## HISTORIC AND DESIGN REVIEW COMMISSION

**HDRC CASE NO:** 2019-079  
**ADDRESS:** 112 LINDELL PLACE  
**LEGAL DESCRIPTION:** NCB 6204 BLK 5 LOT 1  
**ZONING:** MF-33, H, RIO-1  
**CITY COUNCIL DIST.:** 1  
**DISTRICT:** River Road Historic District  
**APPLICANT:** Jim Bailey/Alamo Architects  
**OWNER:** Asher Reilley  
**TYPE OF WORK:** Amendments to a previously approved design including the reconstruction of original walls  
**APPLICATION RECEIVED:** February 15, 2019  
**60-DAY REVIEW:** April 16, 2019  
**REQUEST:**

RE: Engineer's Opinion Statement  
**112 Lindell Place**  
San Antonio, TX

## 1 EXISTING GROUND FLOOR RENOVATIONS

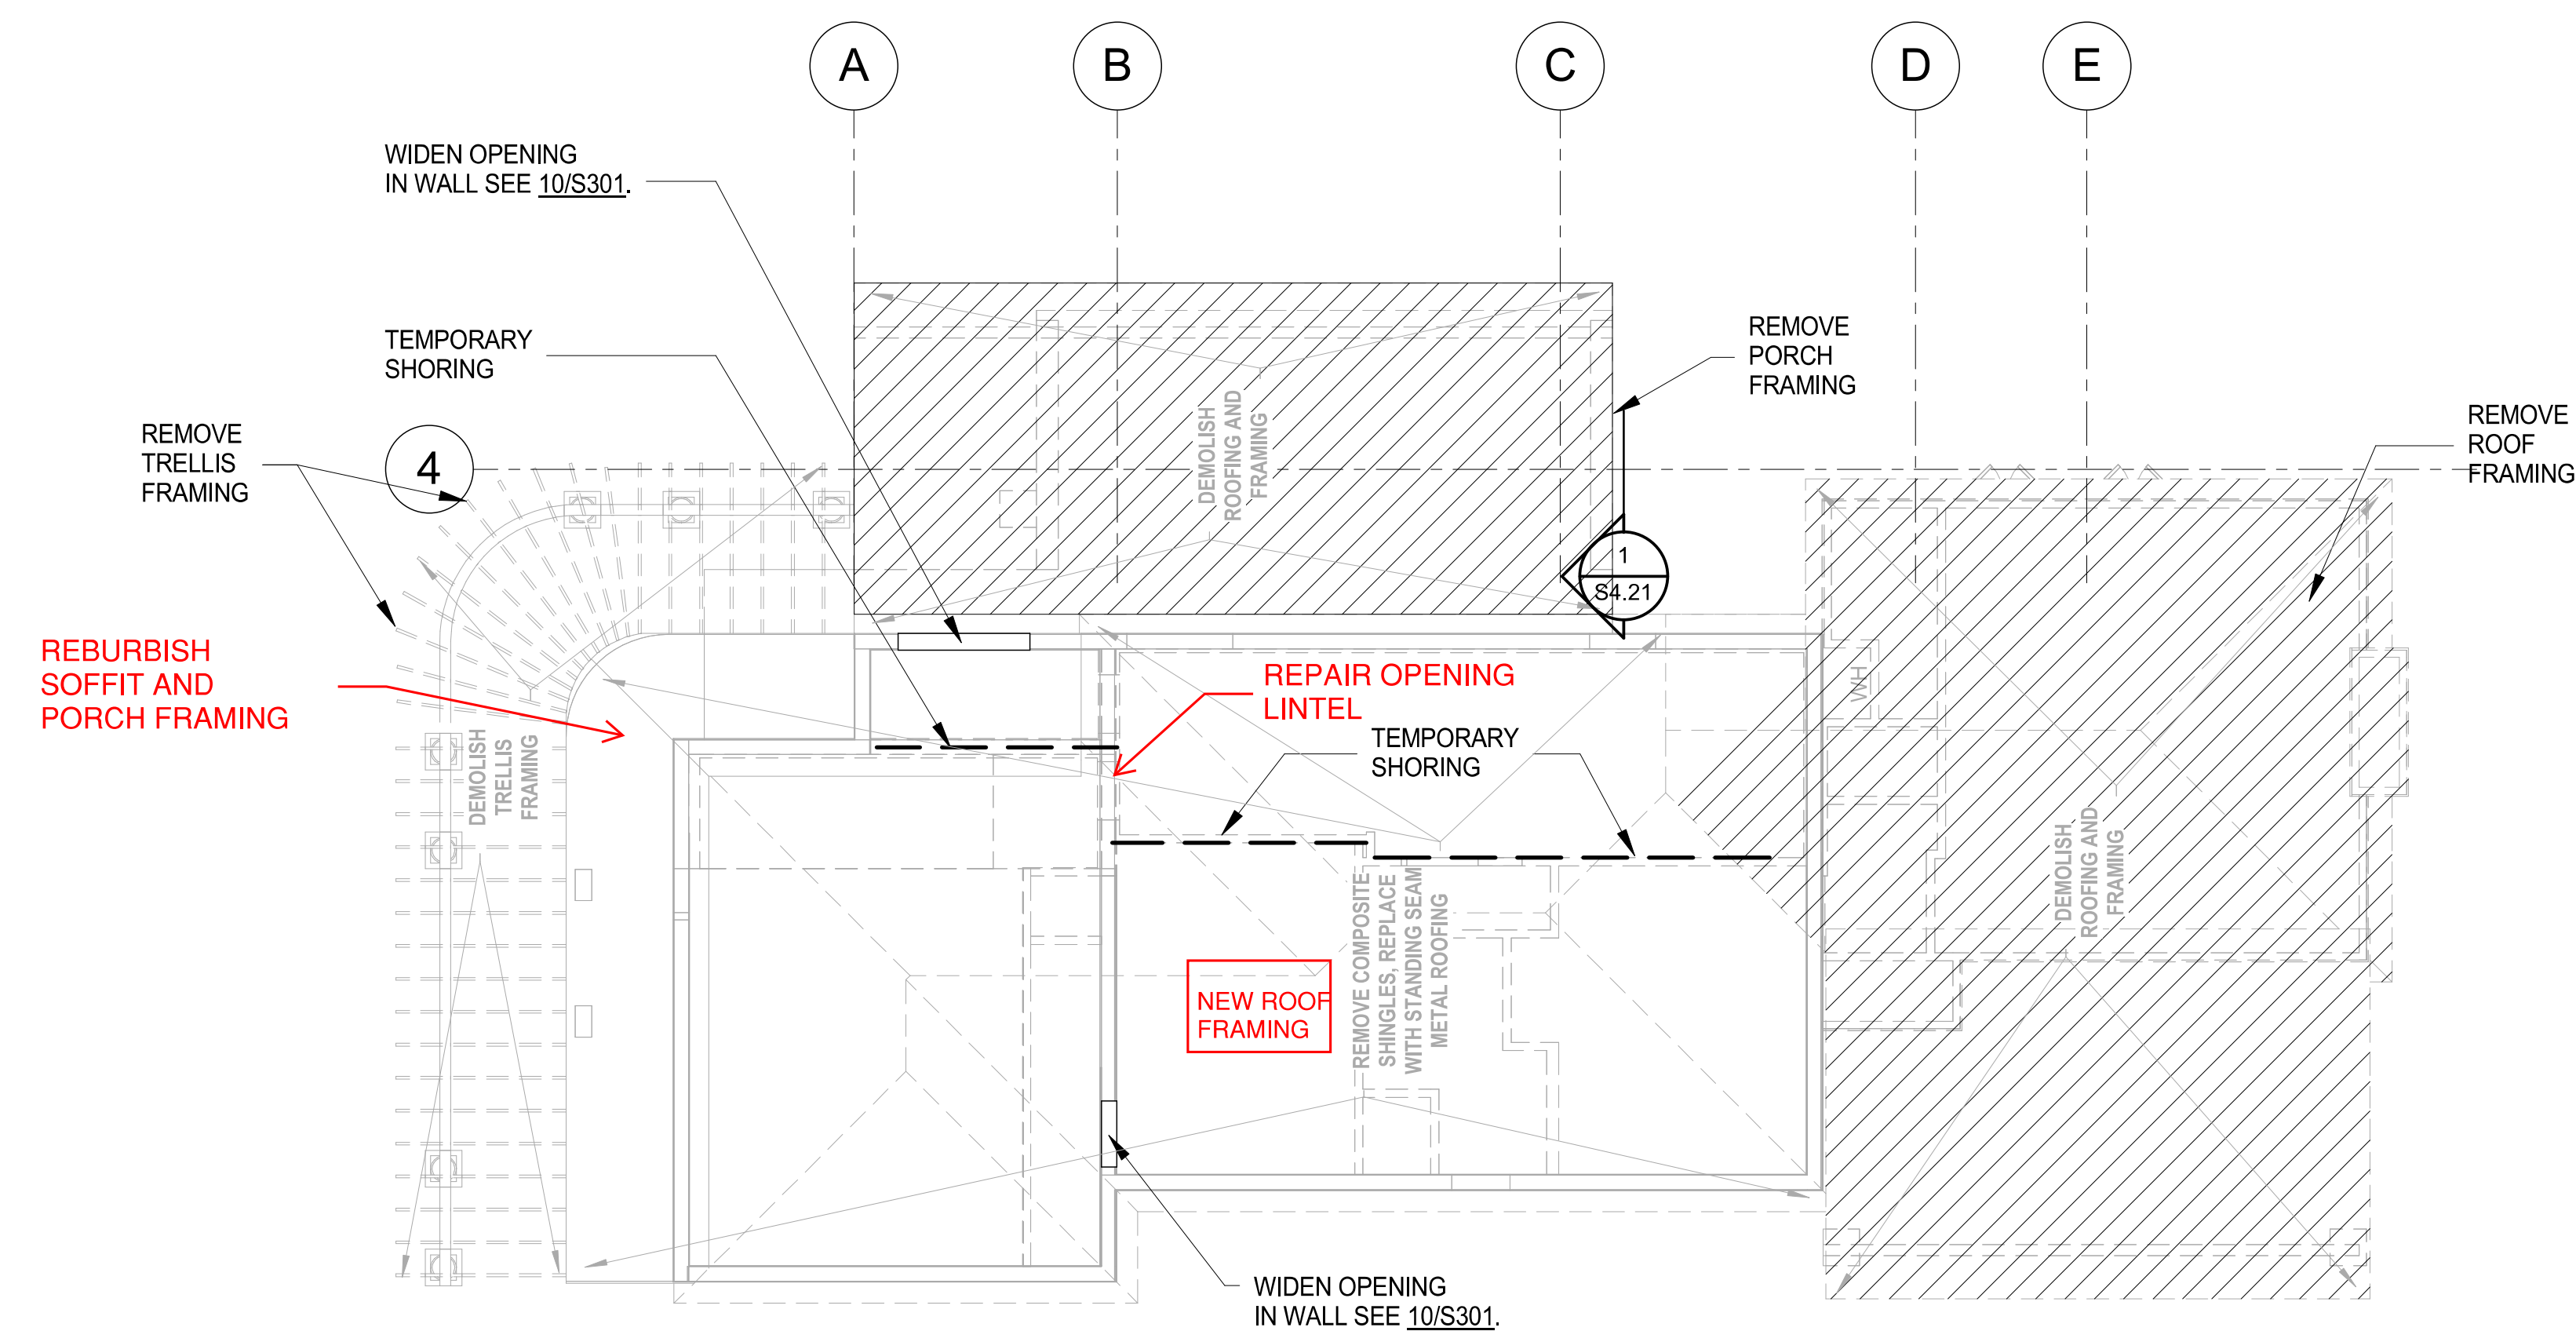
**GROUT AND REPAIR ALL  
CRACKS AND MISSING  
BLOCKS AS REQUIRED.**
